YARIS

OUTLINE OF NEW FEATURES

The following changes are made for the new Yaris.

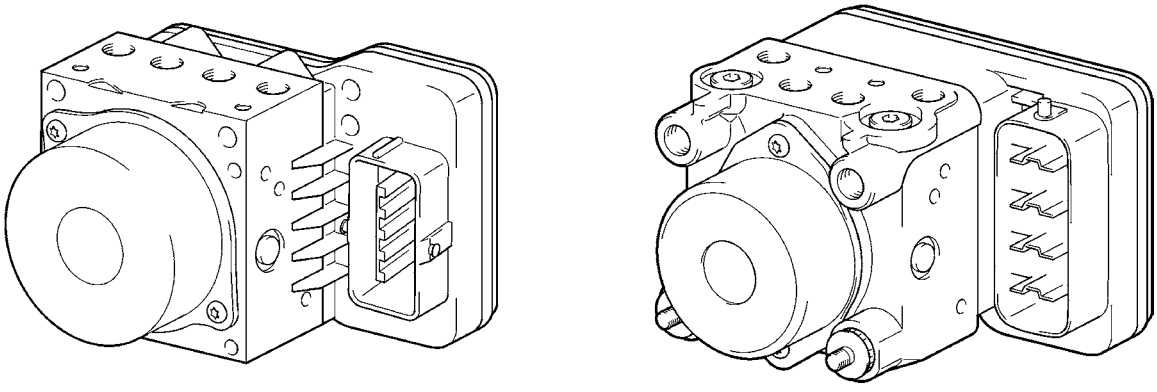
The 175/65R14 tire for Australian models has been discontinued and instead, the 185/60R15 tire has been provided as standard on all models.

Tire Size	185/60R15		
Disc Wheel Size	15 × 5 $^1/_2$J	←	←
Disc Wheel Material	Steel	←	Aluminum
P.C.D.* mm (in.)	100 (3.9)	←	←
Inset mm (in.)	45 mm (1.8 in.)	←	←
Wheel Design	Full Wheel Cap  10RMO17Y	Full Wheel Cap  10RMO18Y	Aluminum Wheel  10RMO19Y
